PROJECT BORN FRAGRANCE - shop fit-out

TITLE **SETTING-OUT PLAN**

REV 00 - preliminary

PRELIMINARY - NOT FOR CONSTRUCTION

SHEET **SD-06**

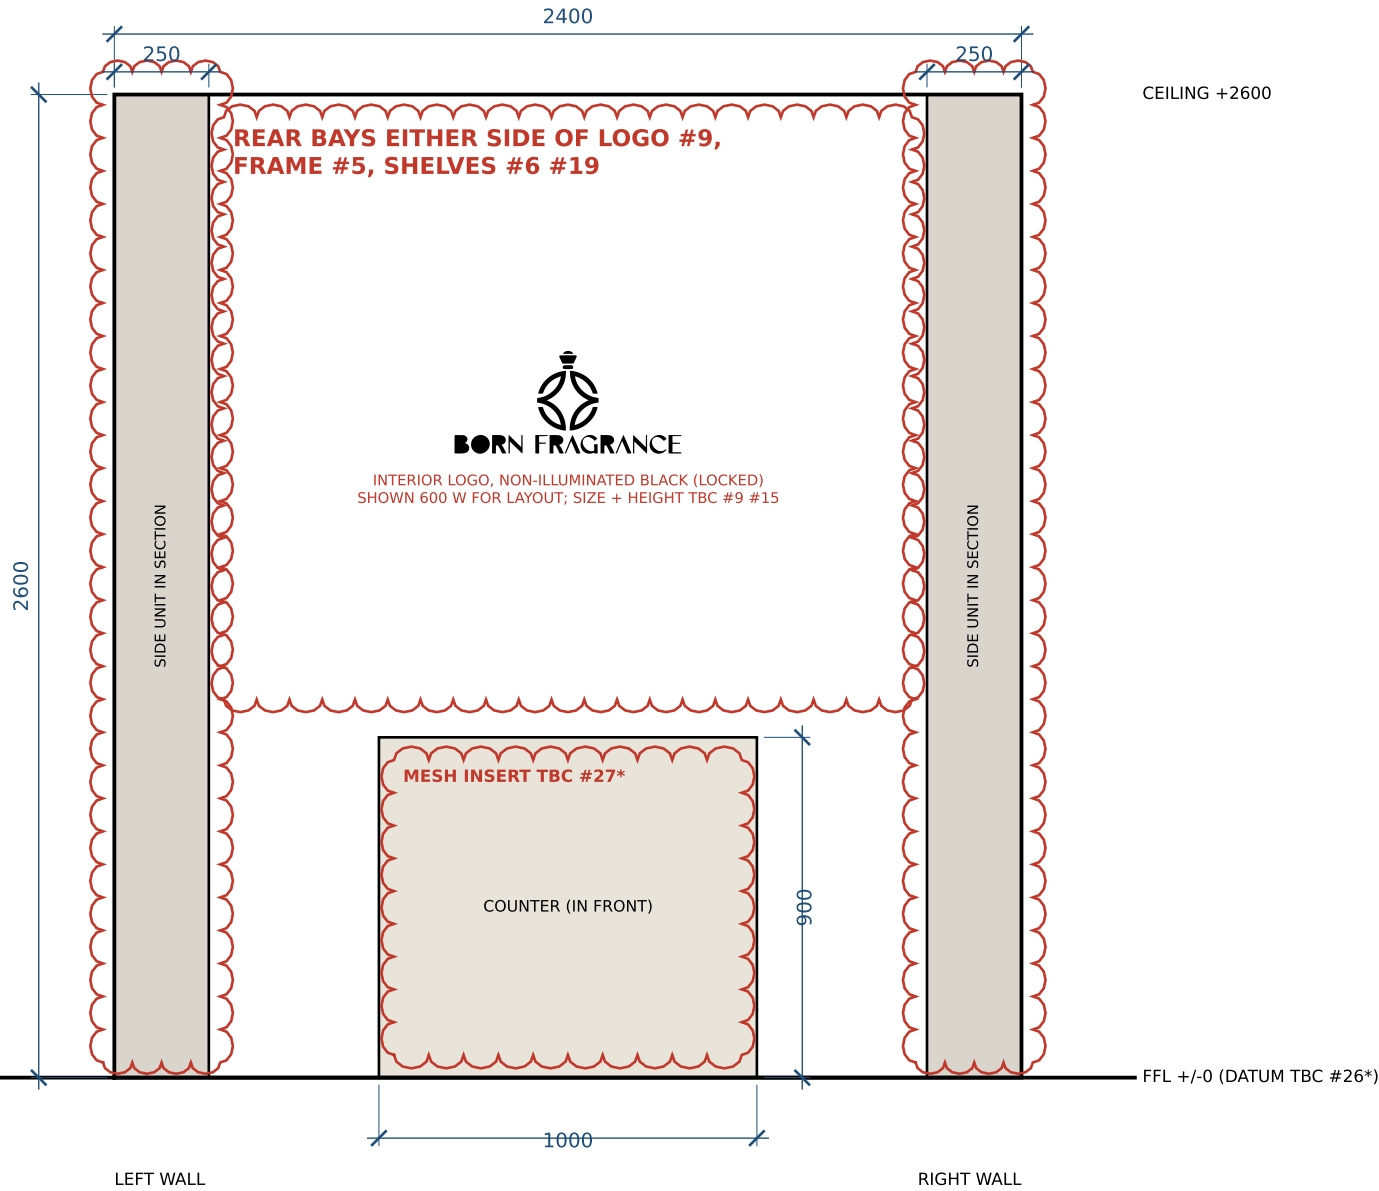
Counter x 700-1700 is a PROPOSAL (#25*); mesh insert size TBC #27*.

- #5 Display frame height (to ceiling or stopped short)
- #6 Shelf count and pitch per bay
- #7 Base cabinet height and door type
- #9 Rear wall bay width, shelf count, logo size and height
- #15 Exterior and interior sign sizes
- #19 Shelf material and thickness (render board: "black metal shelf")
- #25* Counter lateral position (centring is a proposal)
- #26* Vertical datum (FFL) and wall thickness / construction
- #27* Counter mesh insert size

SHEET SD-07

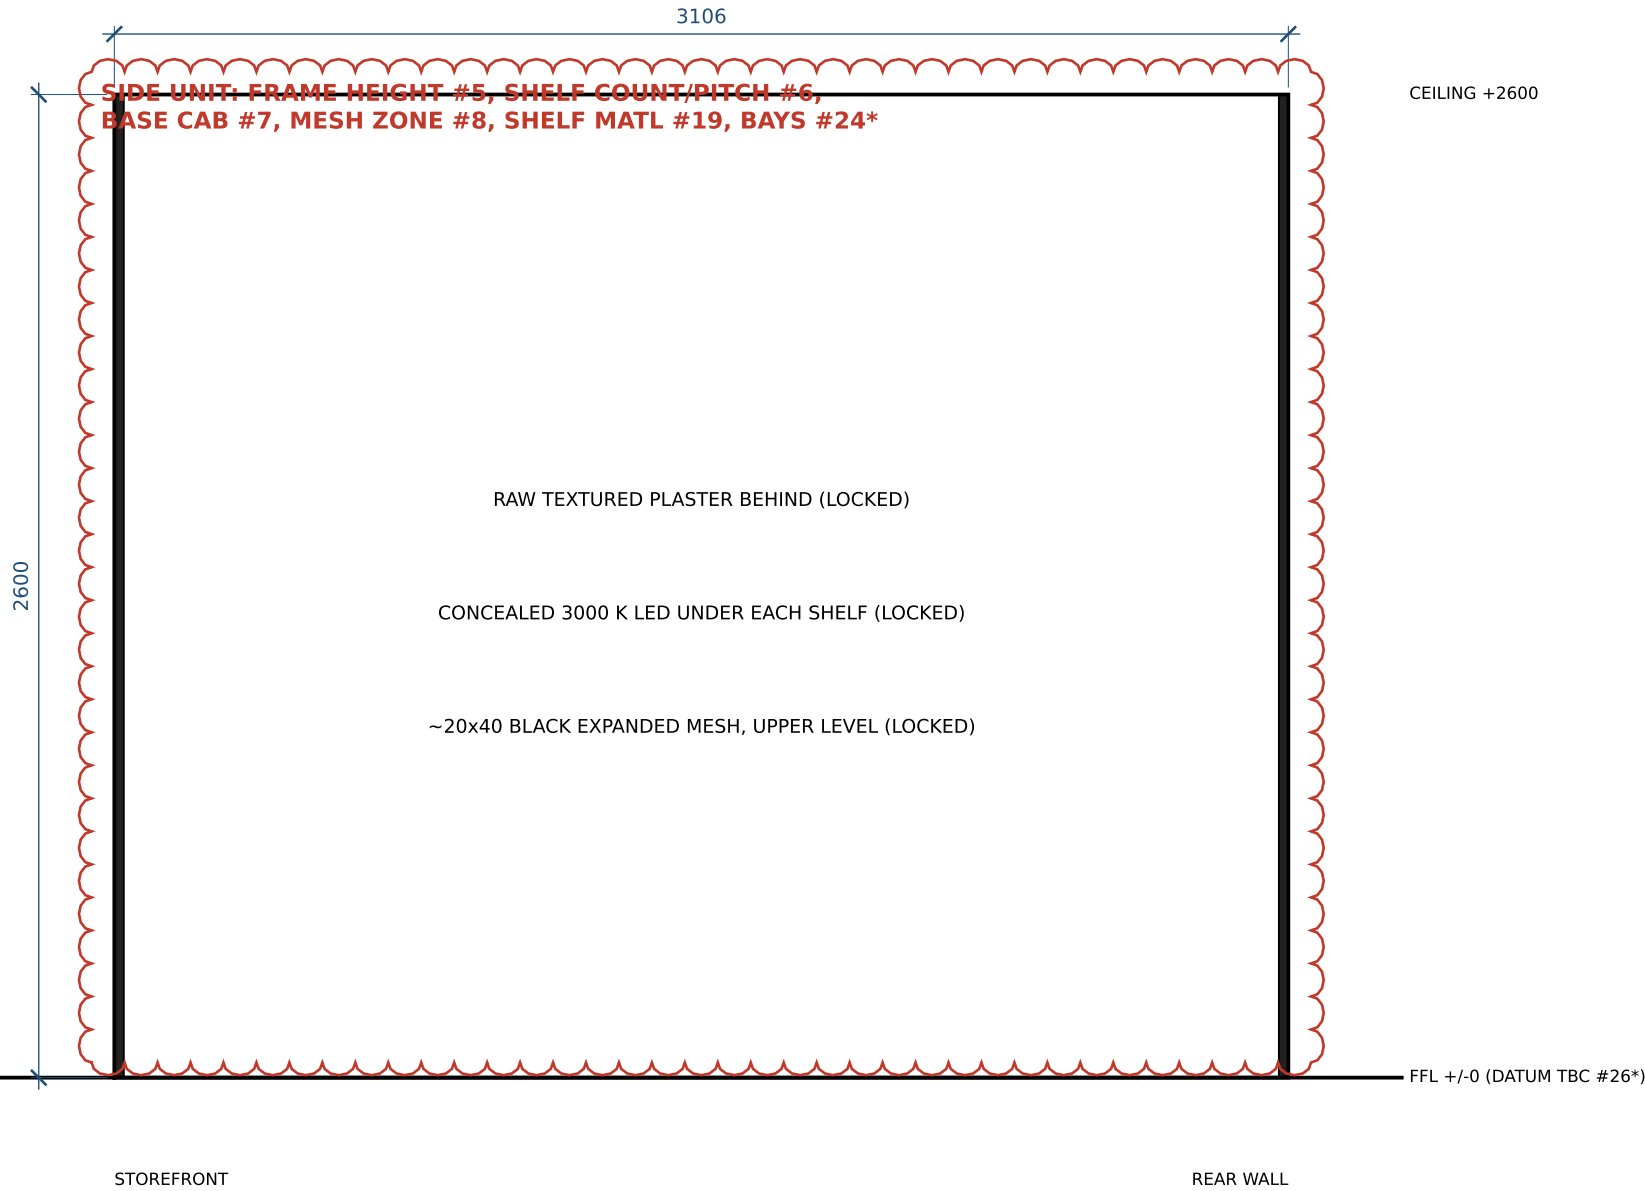
- #5 Display frame height (to ceiling or stopped short)
- #6 Shelf count and pitch per bay
- #7 Base cabinet height and door type
- #8 Mesh extent on side walls
- #9 Rear wall bay width, shelf count, logo size and height
- #18 Storefront display column depth, and shelf facing (street, shop or both)
- #19 Shelf material and thickness (render board: "black metal shelf")
- #24* Side bay count, widths and upright spacing

SHEET **SD-08**

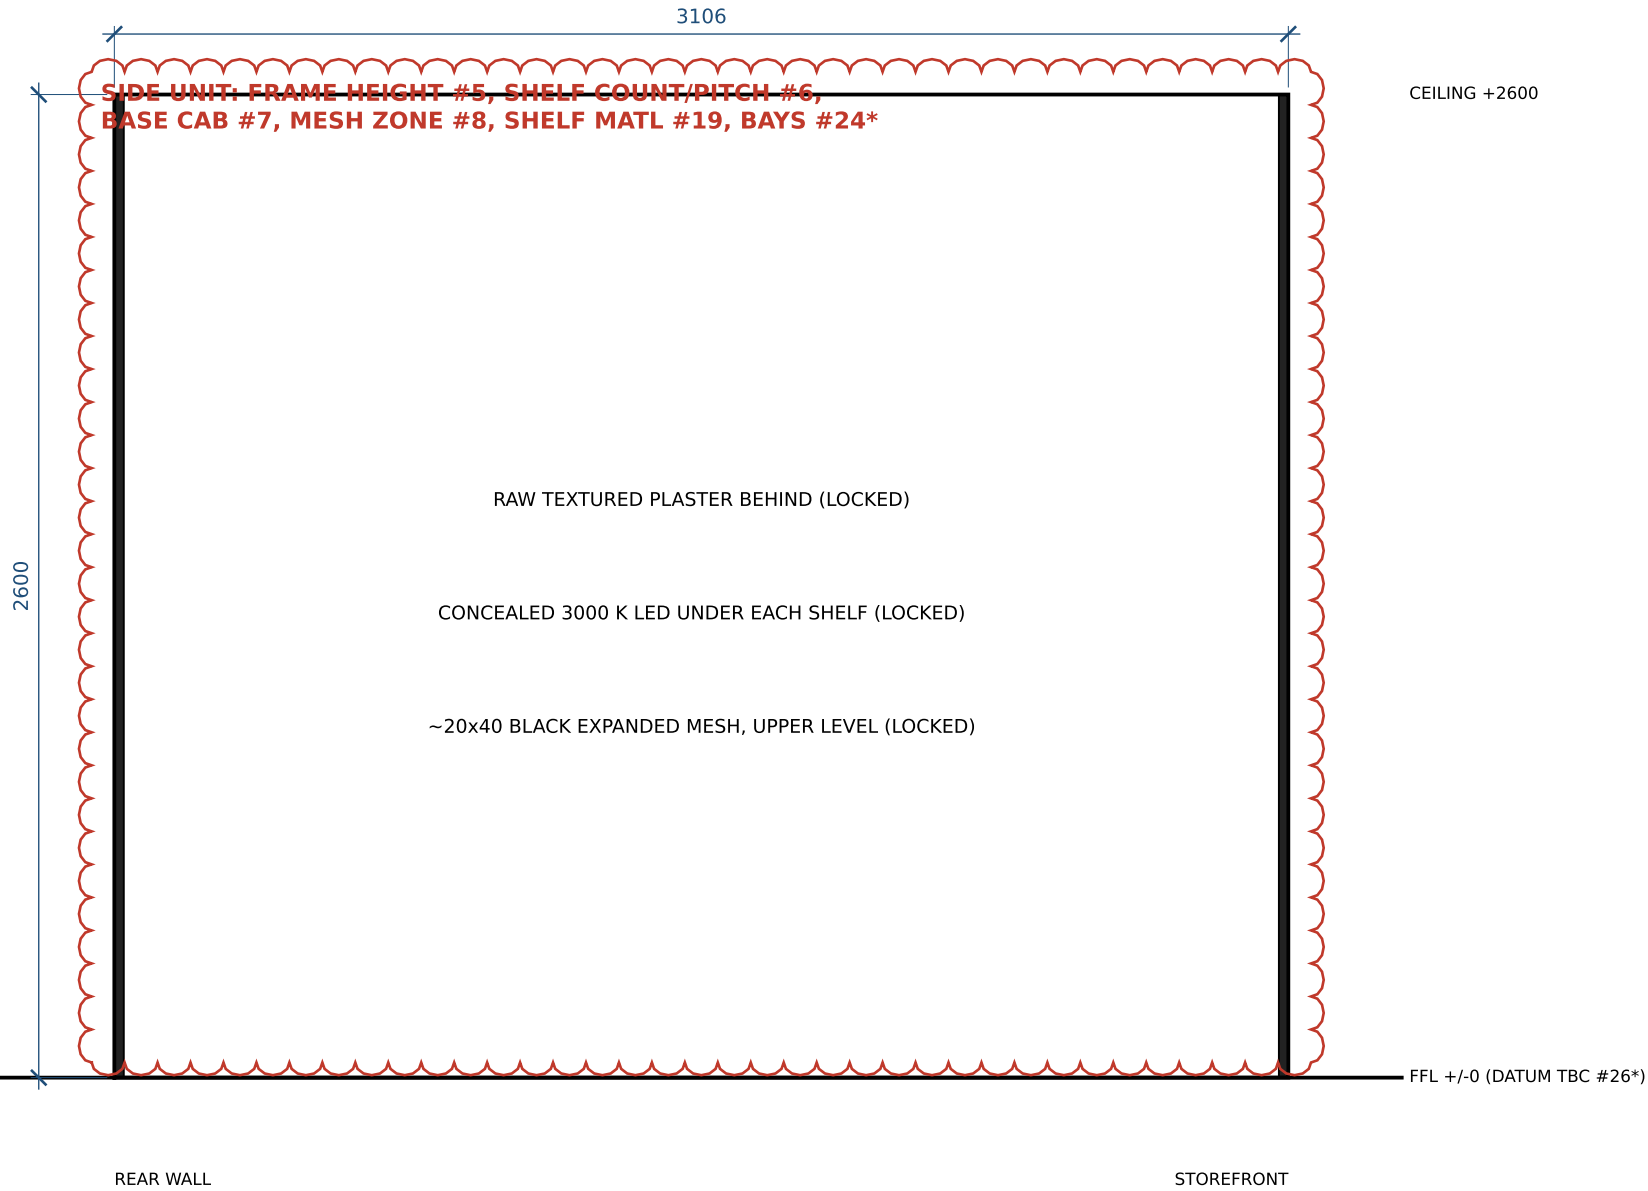
- #5 Display frame height (to ceiling or stopped short)
- #6 Shelf count and pitch per bay
- #7 Base cabinet height and door type
- #8 Mesh extent on side walls
- #9 Rear wall bay width, shelf count, logo size and height
- #18 Storefront display column depth, and shelf facing (street, shop or both)
- #19 Shelf material and thickness (render board: "black metal shelf")
- #24* Side bay count, widths and upright spacing
